**SAN ANTONIO WATER SYSTEM
REGIONAL CARRIZO PROGRAM (RCP):
WATER DELIVERY PIPELINE PROJECT
SAWS Job No. 10-8607 (WATER)
Solicitation No. B-12-002-CM**

ADDENDUM NO. 2

March 23, 2012

SAWS JOB NO. 10-8607
 REGIONAL CARRIZO PROGRAM:
 WATER DELIVERY PIPELINE PROJECT
 PLAN & PROFILE
 STA. 354+00 TO STA. 364+00
 Sheet W40

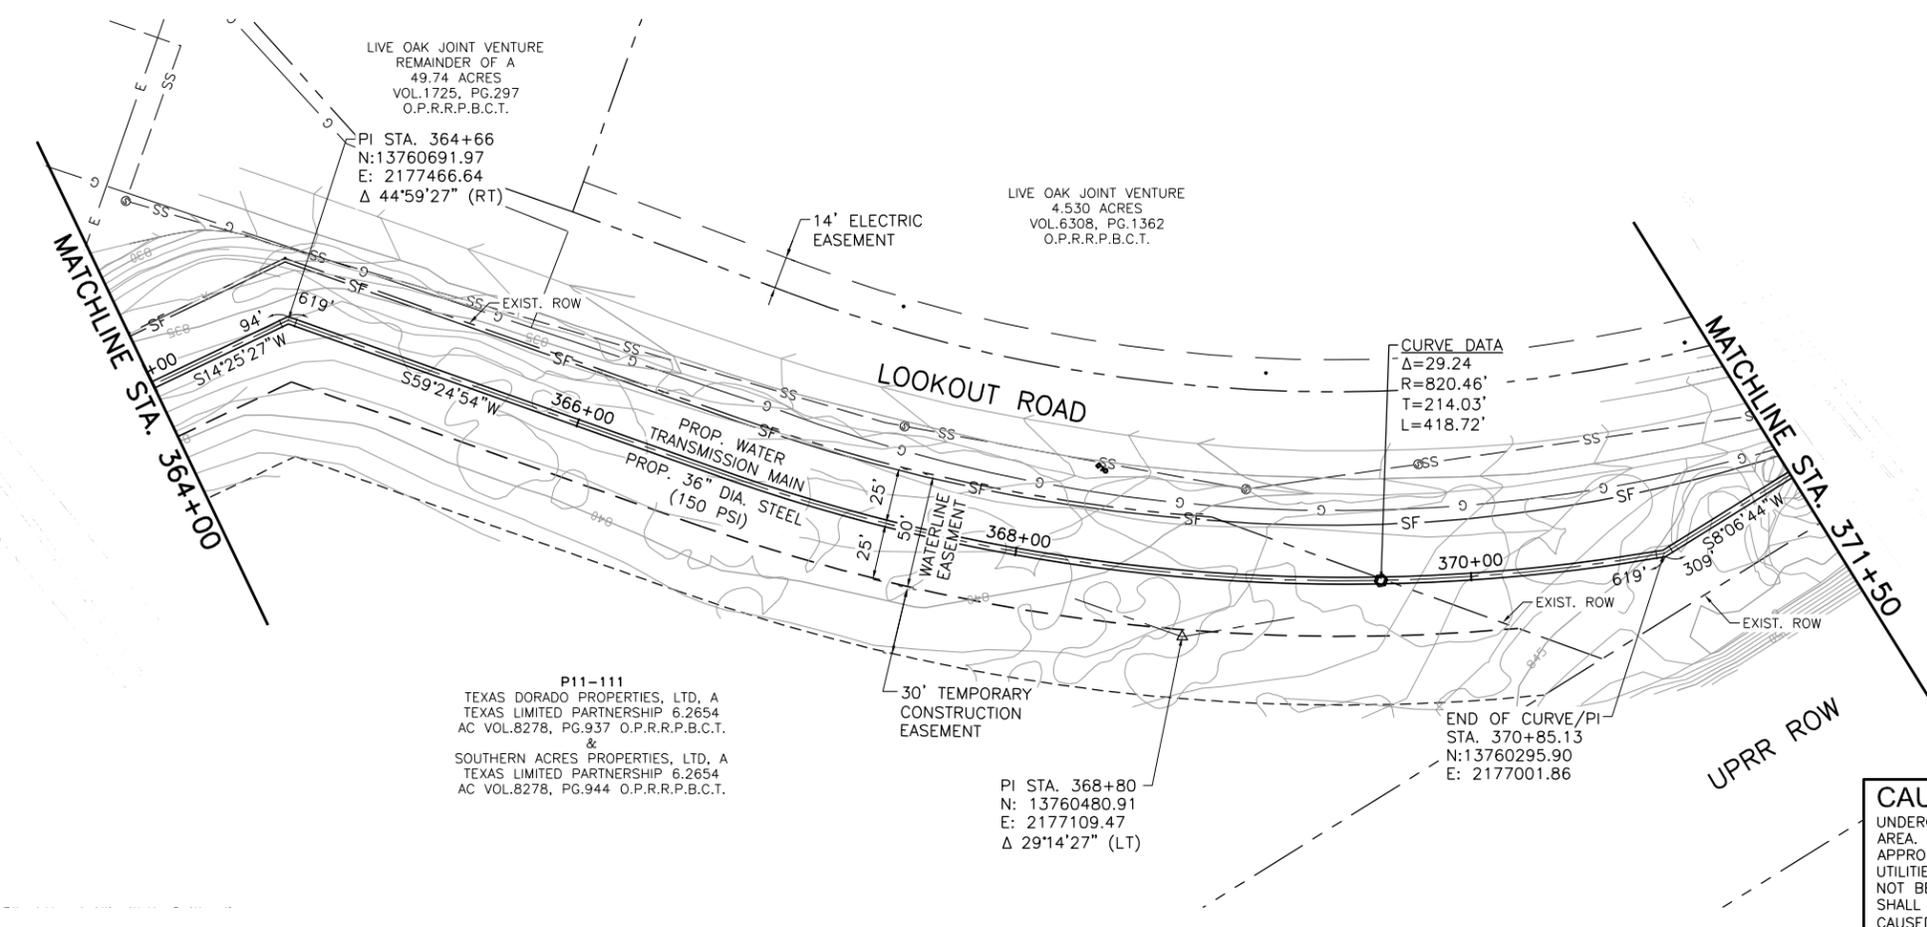
16. SHEET W34, PLAN AND PROFILE: MODIFY PROFILIE VIEW CALLOUT at STA. 300+01 as follows: "STA. 300+01, 4" Type 1, Style B, Air Valve Assembly."
17. SHEET W40, PLAN AND PROFILE: REPLACE this drawing in its entirety with the attached sheet.

JOINT DETAIL
POLYURETHANE OR TAPE COATED STEEL PIPE
 NOT TO SCALE

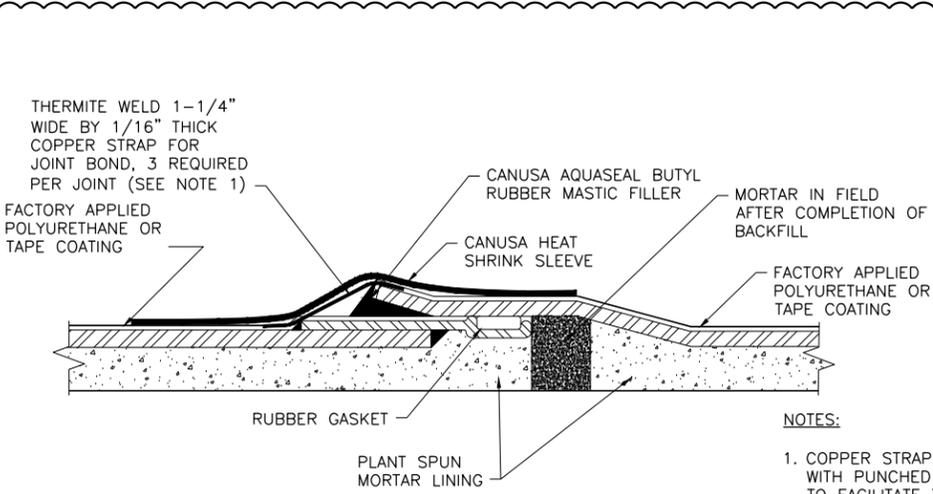
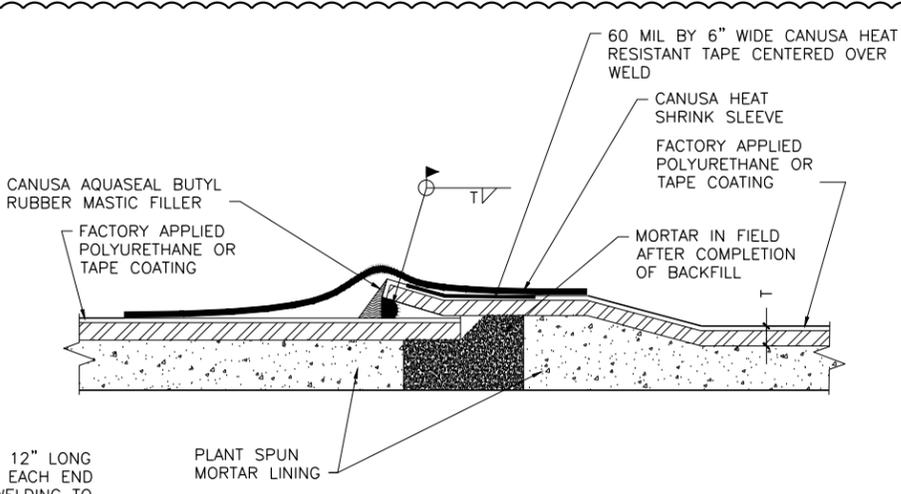
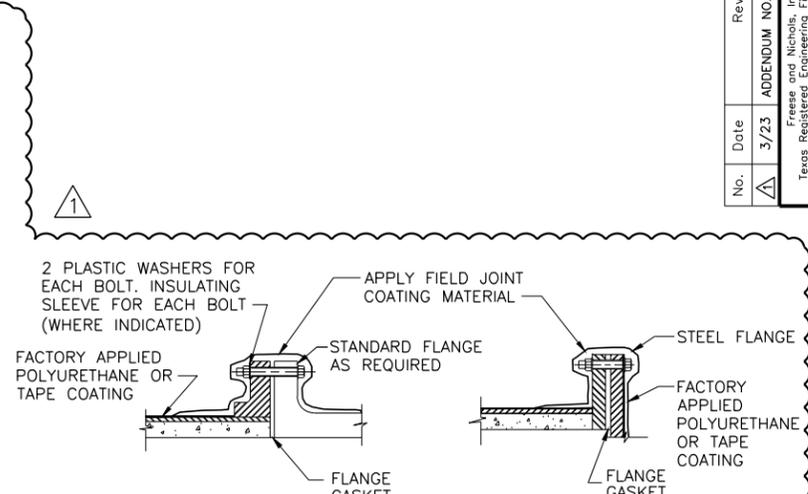
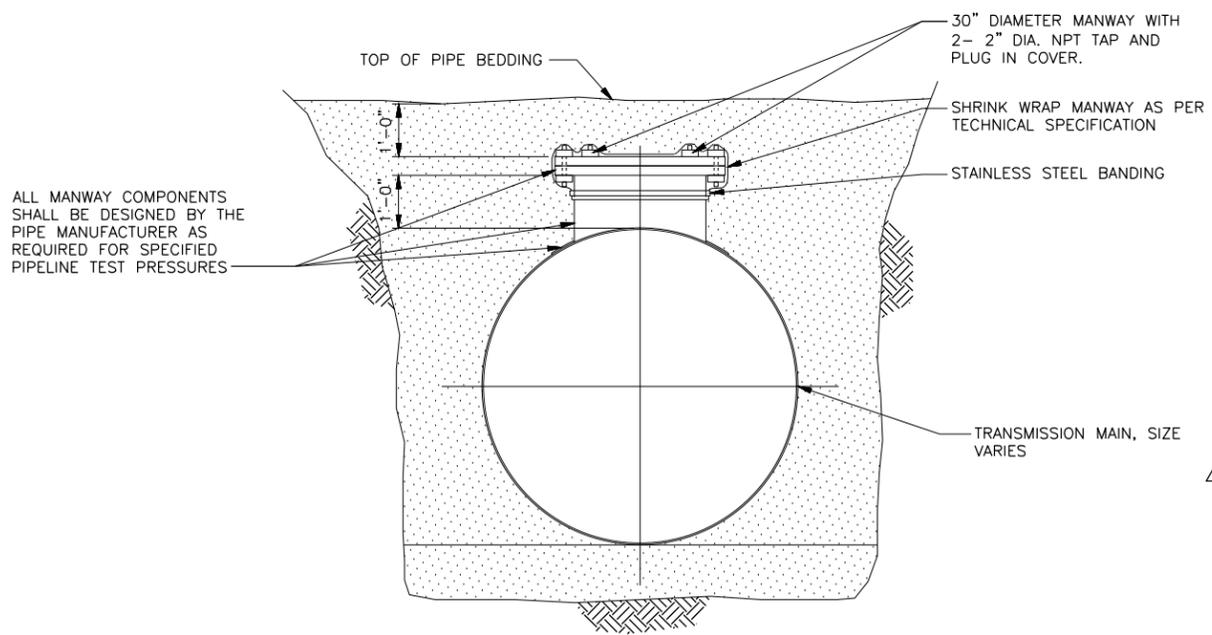
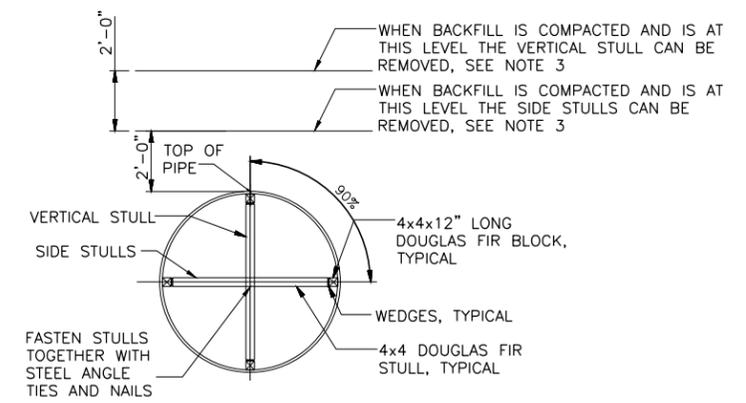
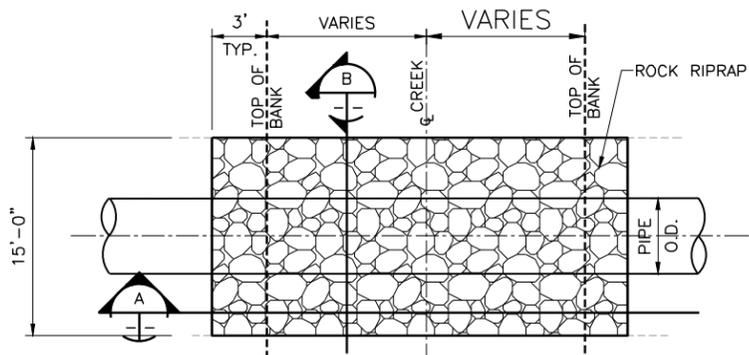
- 26. SHEET DT10, PIPE AND MANWAY DETAILS: REPLACE this drawing in its entirety with the attached sheet.
- 27. SHEET DT14, CREEK CROSSING AND EROSION CONTROL BLANKET DETAILS: REPLACE this drawing in its entirety with the attached sheet.
- 28. SHEET DT15, CONCRETE CABLE MAT AND DRAINAGE STRUCTURE DETAILS, DETAIL 1, SECTION A - PROFILE: REPLACE the leader note as follows: "Two layers of non-woven geotextile, one layer is adhered to the block by the Manufacture, one layer is placed on the subgrade by the Contractor."

3. **Question:** Detail 2 on Sheet DT10 calls out for an *interior* weld. Spec Section 02571-3.05.C reads: "*Exterior* joint welding shall be completed before application of field applied joint coating for 42" and smaller." Please advise if the welded joints are interior or exterior. If the welds are interior, can the Contractor perform weld after backfill if the special techniques are accepted per Spec Section 02571-3.05.D?

Answer: Exterior welding shall be performed for pipe sizes of 42-inch diameter and smaller per Specification Section 02571. See change to Sheet DT10, Detail 2, in Addendum No. 2

RIP RAP CREEK CROSSING DETAILS
SCALE: NOT TO SCALE

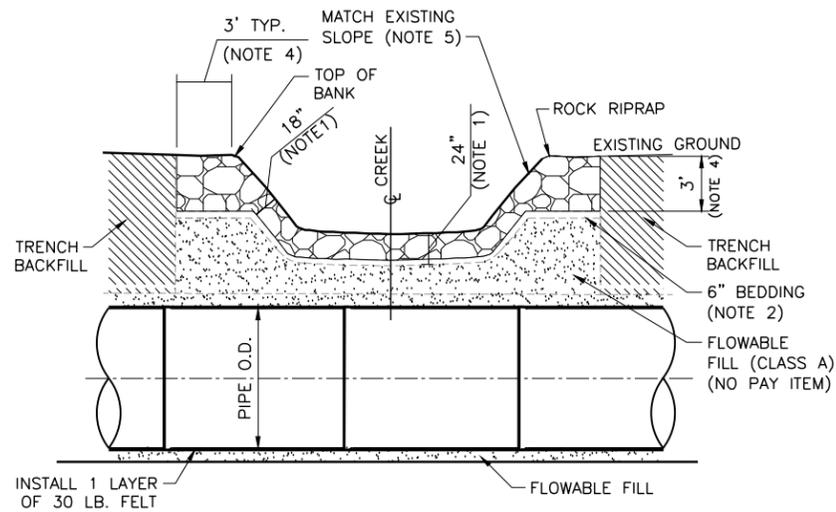
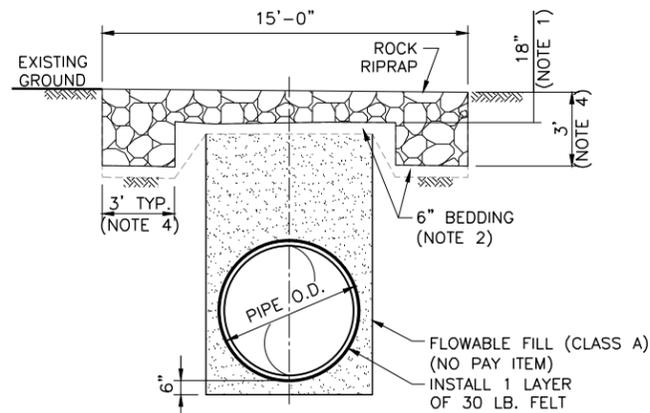
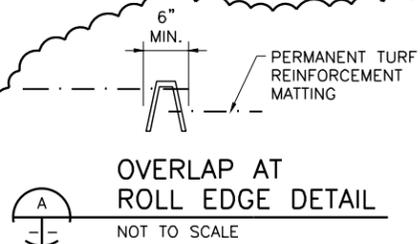
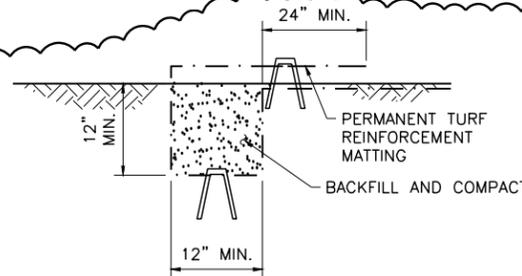
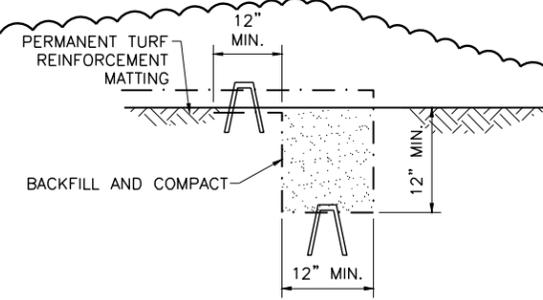
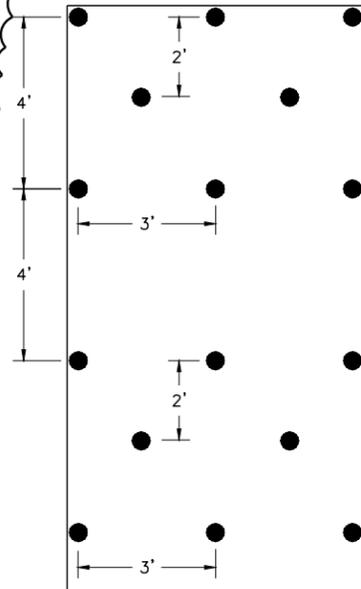
5. **Question:** On plan sheet DT14, Creek Crossing and Erosion Control Blanket Details, the anchor pattern (DOT system) and material dimensions listed are for North American Green Turf Reinforcement Mats. Per section 02270 of the spec book for this project the Turf Reinforcement mat is listed as Pyramat or approved equal. I would like to submit North American Green P-550 for approval as an equivalent TRM on this project. I have included the product specification sheet along with a competitive product profile sheet. If you have any questions please feel free to contact me.
